MIL-C-70582B (AR)
AMENDMENT 2
09 October 1992
SUPERSEDING
AMENDMENT 1
21 August 1991

MILITARY SPECIFICATION

CIRCUIT BOARD, ±24 VOLT CONVERTER, VOLTAGE CONVERTER (PIVADS): 9397385

Figure 1. Burn-in Temperature Versus Time Diagram

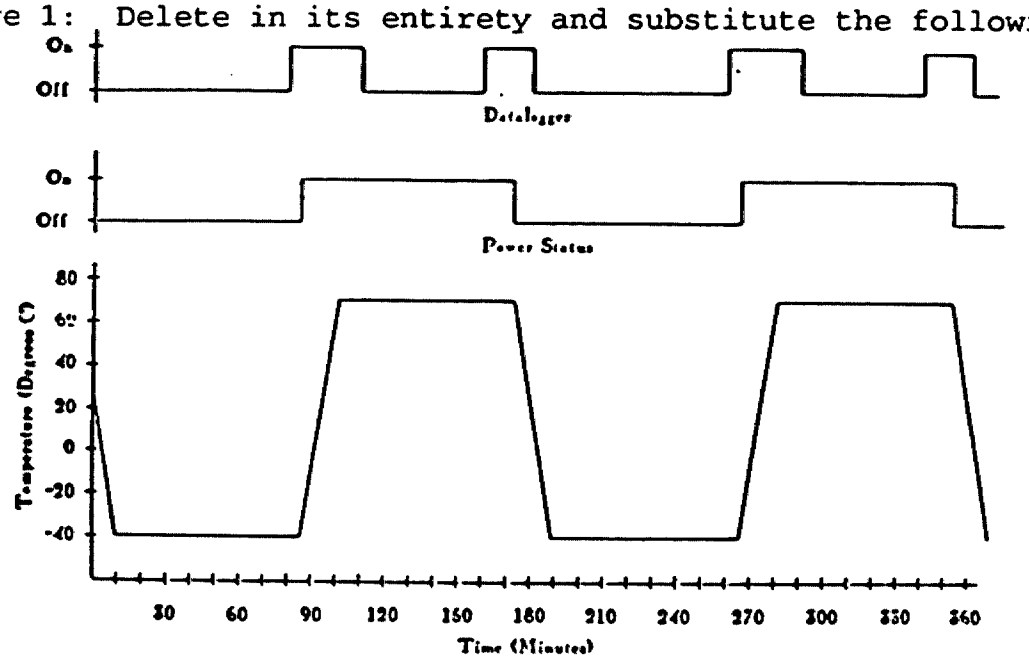
Figure 1: Delete in its entirety and substitute the following:
